GETTLER-RYAN INC.

June 11, 2001

Subject: Clarification of site conditions at Chevron facility #20-6142, located at 333 23rd Street, Oakland, CA.

FIGURE 4
CROSS SECTION A-A'

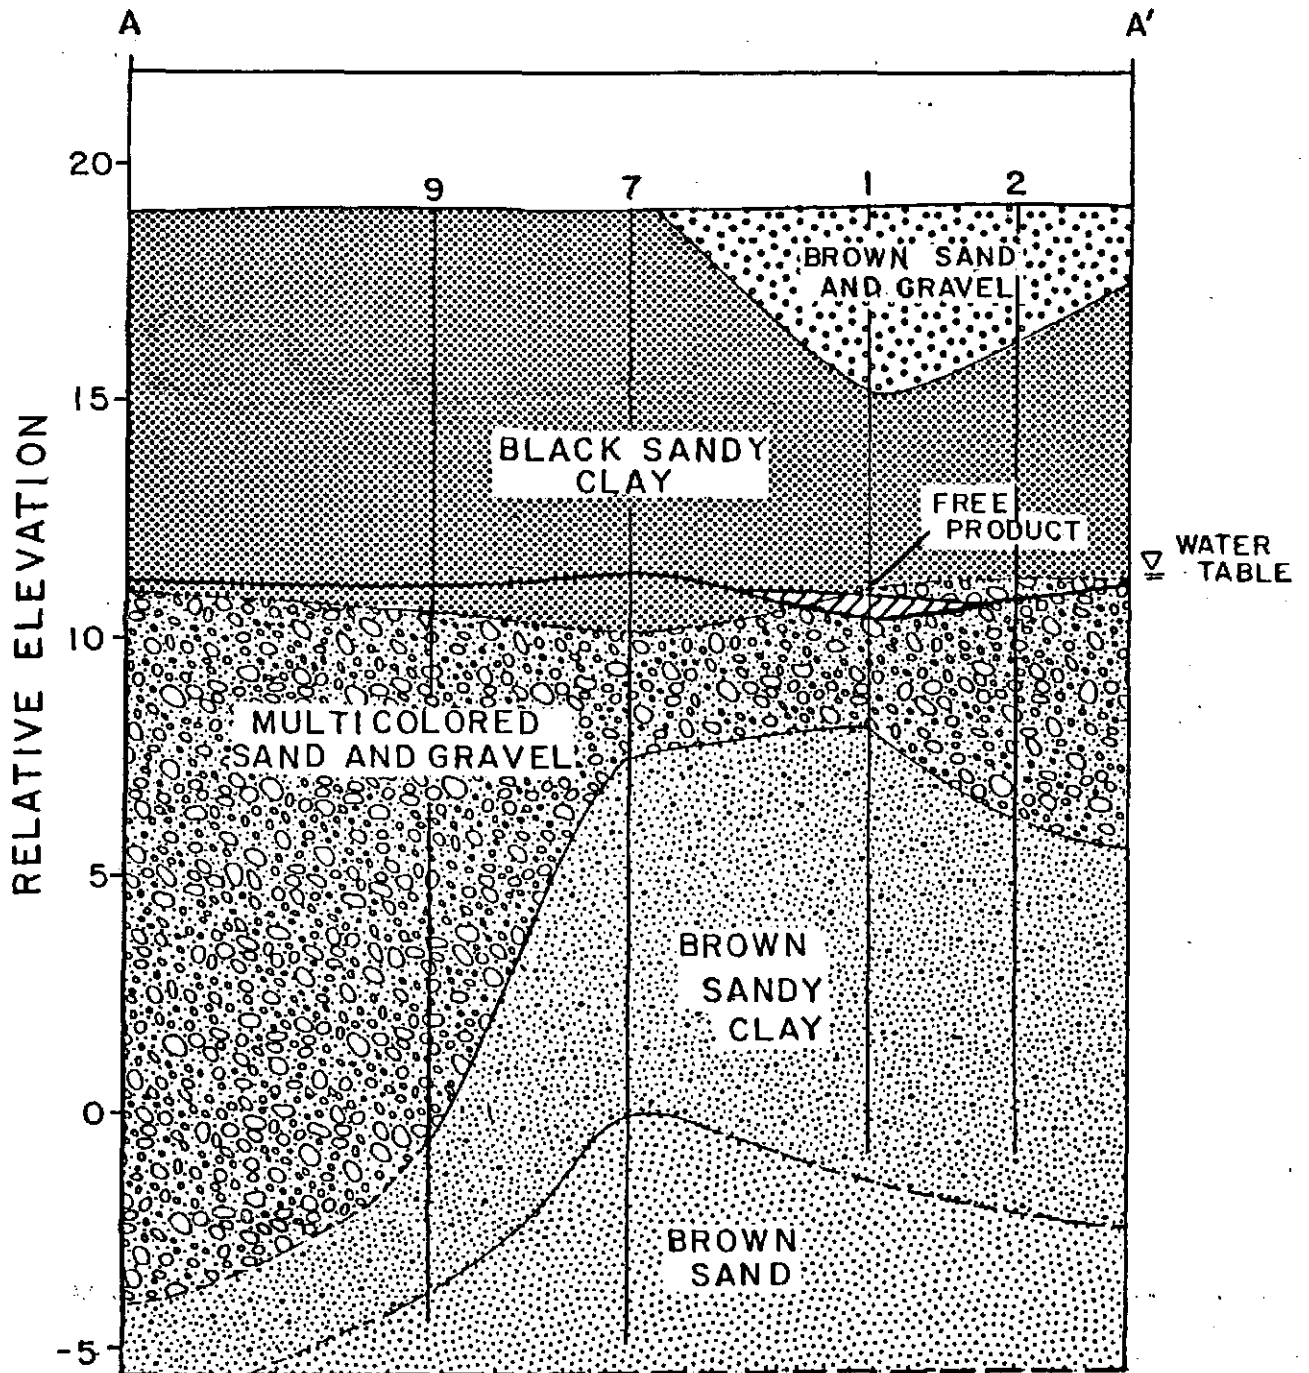
1. **Plume configuration and recovery well location:** You expressed some concern as to why the initial recovery well (R-1, installed in 1986) was installed approximately 65 feet north of the UST pit. You asked if it was possible that the locations of well R-1 and the second recovery well (R-2, installed approximately 15 feet northwest of the UST pit in 1988) might have been switched on the site plans.

It does not appear that the locations of wells R-1 and R-2 have been switched. During subsurface investigations at this site a sand and gravel horizon was encountered at approximately 8 to 11 feet below ground surface. This is depicted in illustrations included in GTI's report titled *Hydrogeologic Investigation at Rhodes-Jamieson Concrete Plant, Oakland, California* (dated January 8, 1986). Copies of the fence diagram and cross-sections from this report (attached) show this coarse-grained horizon. The GTI report also includes data on initial product thicknesses in the wells. These data indicate that the free product plume was initially thickest in the vicinity of well MW-8 (refer to attached product thickness map).
